ADDENDUM

re: Job 98096 KABOWASHI

Subject: ADDENDUM to the Structural Investigation Report of the Roof for the Residence located at 6331 Seastone Way, Sacramento, CA 95831.

Subject: Contract Change Order Number 01

ROOF PLAN
 HTS

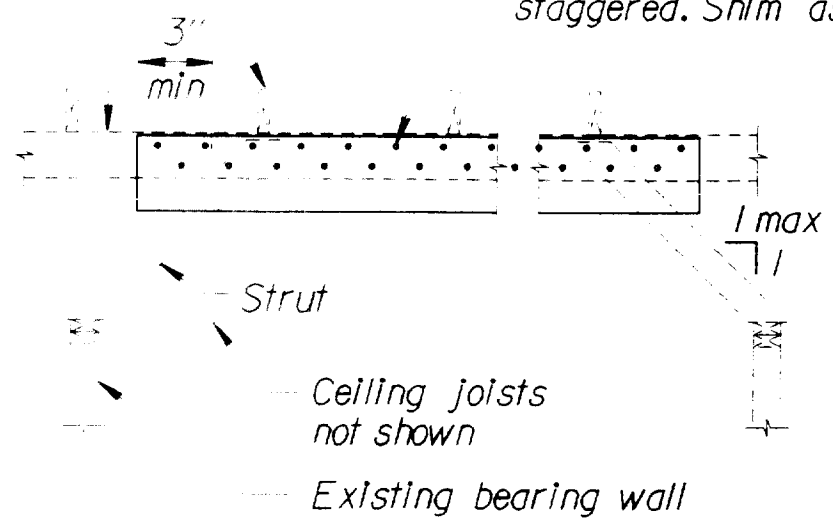
SCAB 2x12 x 12' TO EXISTING PURLIN (2)

SCAB 1x8 x 8' TO EXISTING PURLIN (2)

ADD 2x6 COLLAR TIES (TOTAL 4)
only two are shown (3)

SCAB 2x4 TO EXISTING RAFTER (TOT 2)

only six are shown.

not installed

SEE JUNE 14, 2001
 ADDENDUM ITEMS, MP.
6/19/01

GUSSET PLATE DETAIL

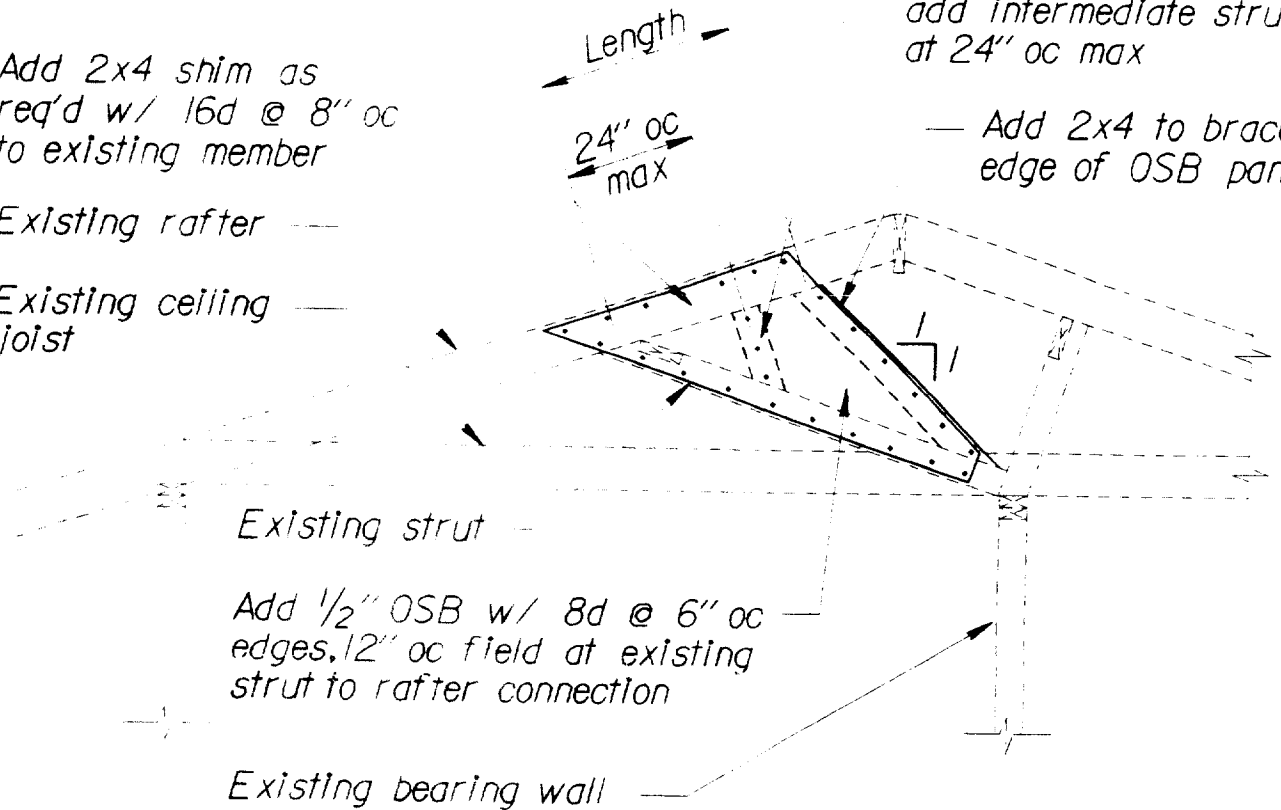
- Item 1: The 2x12 DF#2 x 12'-0" long purlin at the front of the residence that was to have been scabbed to the 2x4 purlin which spans 12'-0" may be replaced with 2x4 struts from the existing purlins to the bearing walls below
- Item 2: The 1/2" OSB gusset plate at the front of the residence may be replaced with 2x4s scabbed to the existing rafters with 16d's @ 12" on center (total 10).
- Item 3: Two of four the collar ties to be added were relocated to the middle of the residence where the rafters were doubled in item 1 above.
- Item 4: Only 3 full-length rafters in the garage require 2x6's scabbed to the side.

1. The 2x12 DF#2 x 12'-0" long purlin that was to have been scabbed to the 2x4 purlin which spans 12'-0" may be replaced with 2x4 struts from the existing purlins to the bearing walls below.
2. The 1/2" OSB gusset plate and additional 2x4 strut may be replaced with 2x4s scabbed to the existing rafters with 16d's @ 12" on center.

Add 1/2" OSB w/ 8d @ 6" oc edges, 12" oc field at existing strut to rafter connection
